NL-14-1530

**Edwin I. Hatch Nuclear Plant – Units 1 and 2
Response to NRC Request for Additional Information Regarding
Request to Add Critical Instrument Electrical Bus in LCO 3.8.7**

Response to NRC Draft Request for Information

Location of Unit 2 FLEX Bus 1R25 S066 and 1R25-S067

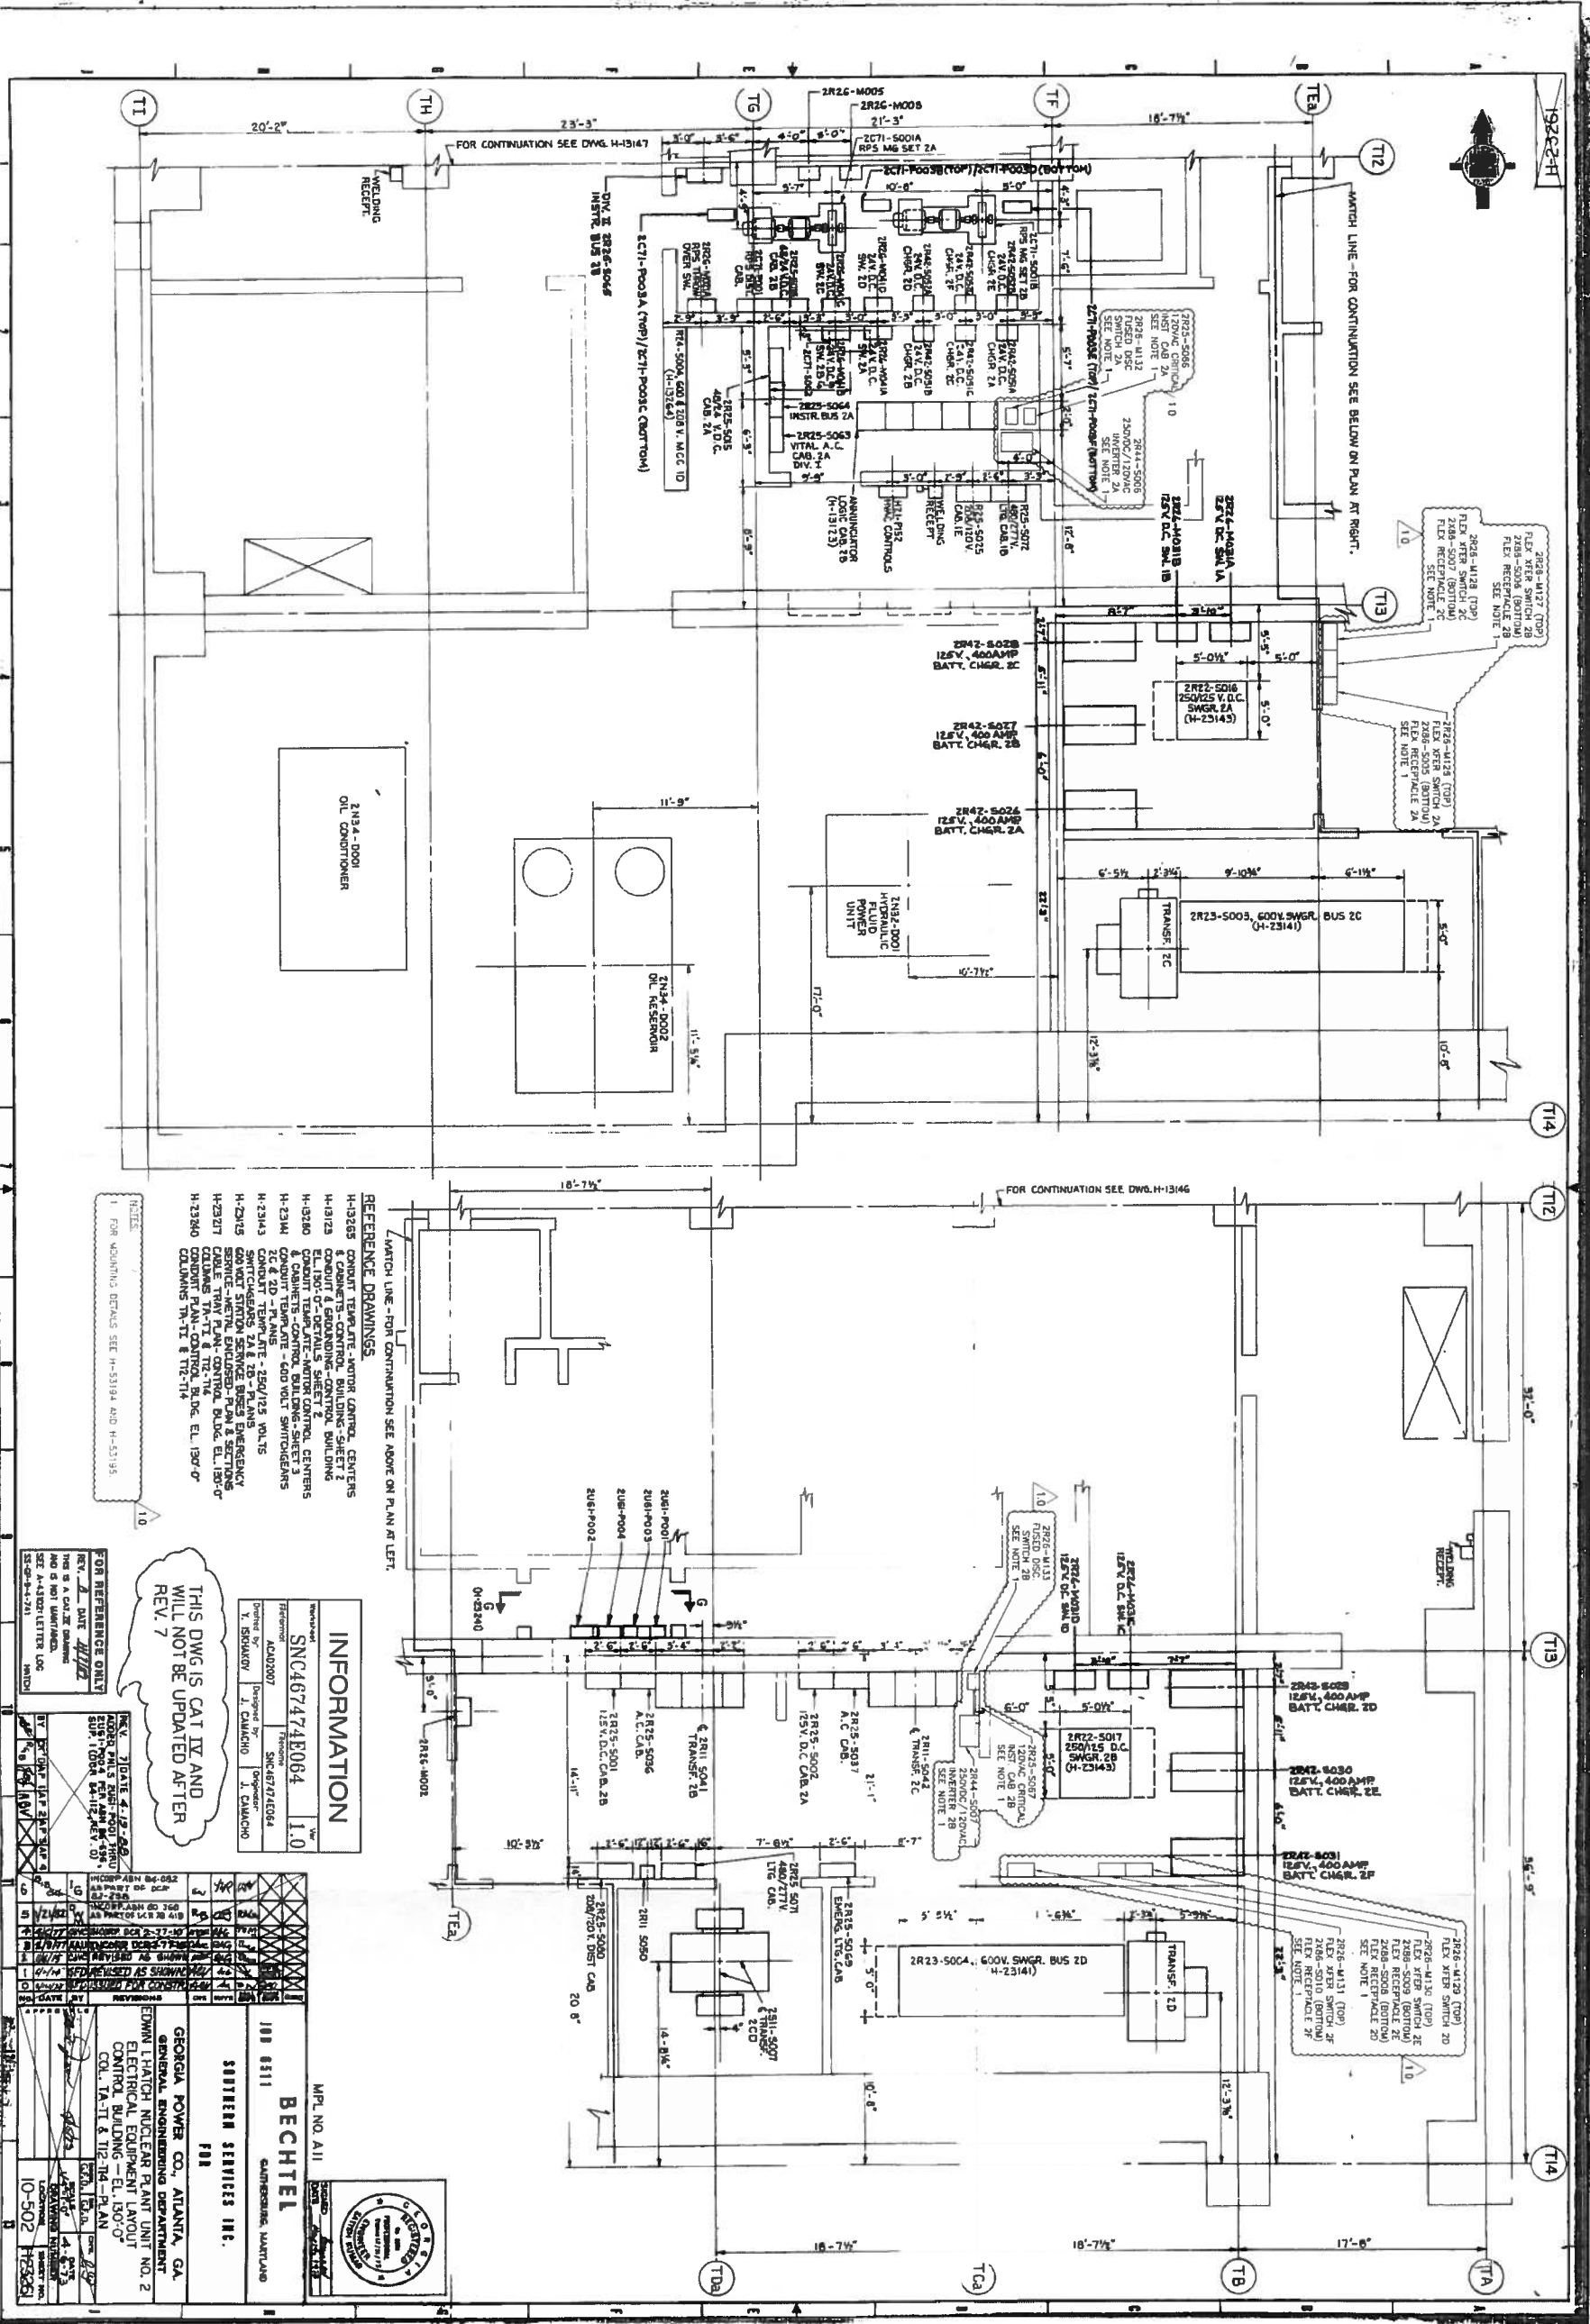
Please provide details on the physical separation between the two trains of critical instrument buses, and a discussion of the adequacy of physical separation between the buses.

Since the Division I and Division II critical instrument cabinets are located in separate fire areas as shown in Attachment 1 for Unit 2 and Attachment 2 for Unit 1, the equipment meets the requirements listed in FHA section 4.2

Load Profile for Battery 1A

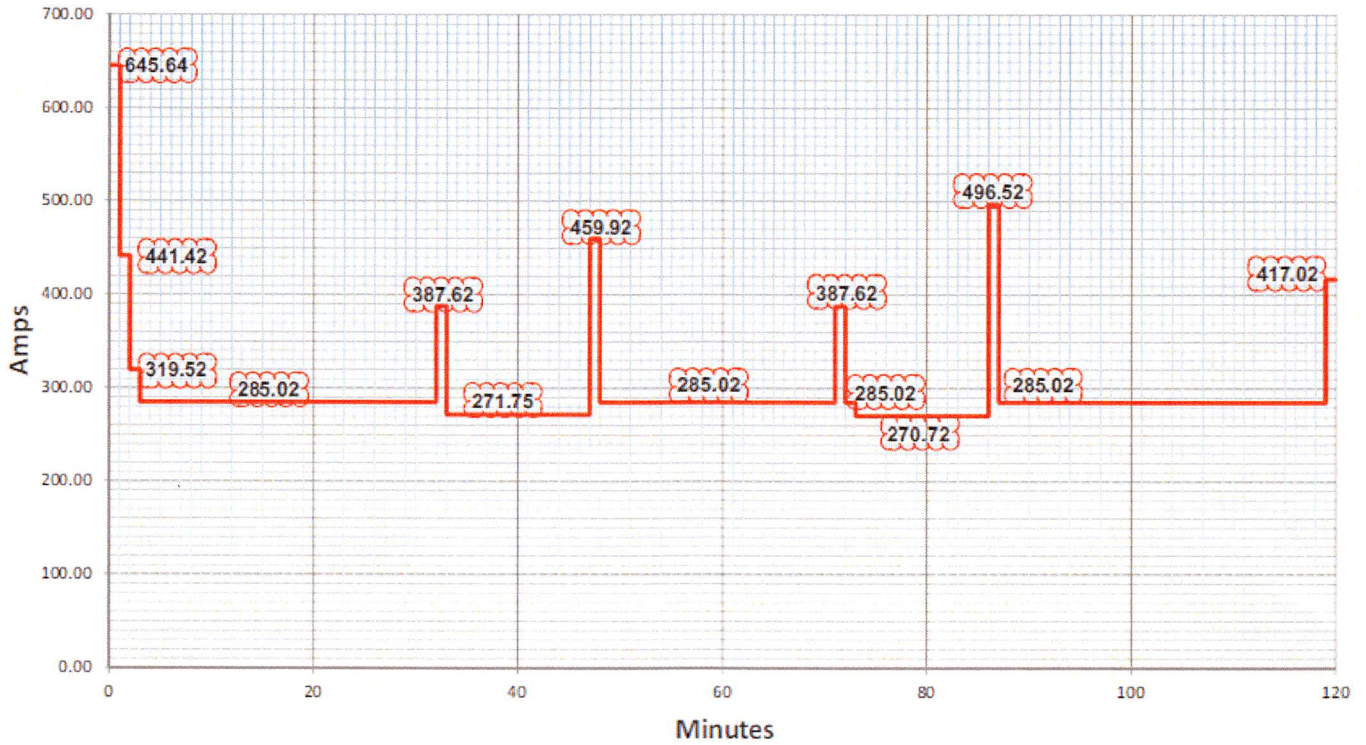
Please provide a summary of the analysis performed to determine the impact of adding additional loads on battery and battery charger sizing, and load profiles for surveillance tests. Confirm that the minimum battery voltage will continue to provide the minimum required voltage at the downstream devices to perform their safety function.

The 27.26A increase in continuous loading from inverter 1R44-S006 reduces the available margin on the battery. The conclusion section of the base calculation SENH-92-137 documents the spare margin is 49.63% for 60/120 cells, 39.45% for 59/118 cells,

The 13.56A increase in continuous loading from inverter 1R44-S007 reduces the available margin on the battery. The conclusion section of the base calculation SENH-92-136 documents the spare margin is 18.92% for 60/120 cells and 6.18% for 59/118 cells before the Design Margin will have to be changed. The total design margin on Station Service battery 1B with the implementation of the design change will be 15.48% for 60/120 cells and 3.29% for 59/118 cells. The Base calculation recommends that the minimum Design Margin be 5%. The 60/120 cell case is above the minimum (i.e. 10.48%), however, the 59/118 cell case is -1.71%, which is below the minimum. Upon the implementation of the design change, which replaces existing MCR incandescent lighting with LED bulbs, the resulting total spare margin will be 18.25% for the 60/120 cell case and 5.63% for the 59/118 cell case. Unlike the Unit 2 calculations, the 5% design margin was not included in the calculated spare margin percentage values. Nevertheless, when the 5% design margin is taken into account, the resultant total spare margin will be 13.25% and 0.63%, which is acceptable for both of these cases.

The load profiles for Station Service Batteries 2A, 2B, 1A, and 1B are provided in Attachment 3.
